MONTGOMERY COUNTY PLANNING DEPARTMENT
THE MARYLAND-NATIONAL CAPITAL PARK AND PLANNING COMMISSION

MEMORANDUM

REVIEW TYPE: **Site Plan Review**
Final Water Quality Plan

PROJECT NAME: **Bowie Mill Estates**

Proposed Lot Configuration Along the Northern Site Boundary

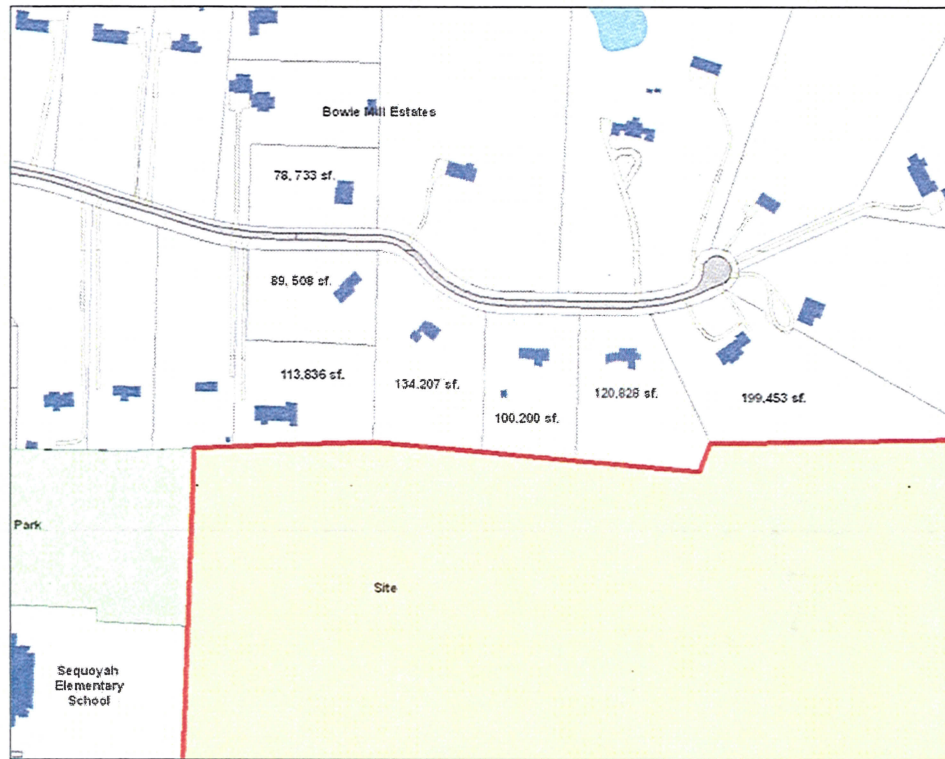
Another issue staff addressed with the applicant is the compatibility of the proposed lot sizes along the northern boundary of the site, directly adjacent to the existing lots on Foggy Lane. The Bowie Mill Civic Association, representing the existing Bowie Mill Estates, has expressed concern that the lots at the northern edge of the proposed site plan are not large enough to be compatible with the existing lots. In response to this concern, staff requested that the applicant reduce the number of lots proposed on that boundary.

Consistent with staff recommendation, the applicant has reduced the number of proposed lots along the northern boundary from nine to eight. These eight lots range in size from 78,769 sf. to 91,071 sf., with an average lot size is 85,441 sf., approximately two acres. The existing lots immediately adjacent range in size from 113,836 sf. to 199,455 sf. with an average lot size of

Staff supports the reduction in number and associated increase in size of the lots. Staff believes the increased size and proposed depths of the lots along the northern boundary of the site are compatible with the adjacent lots and in keeping with the Rural Neighborhood Cluster zone and the Upper Rock Creek Master Plan.
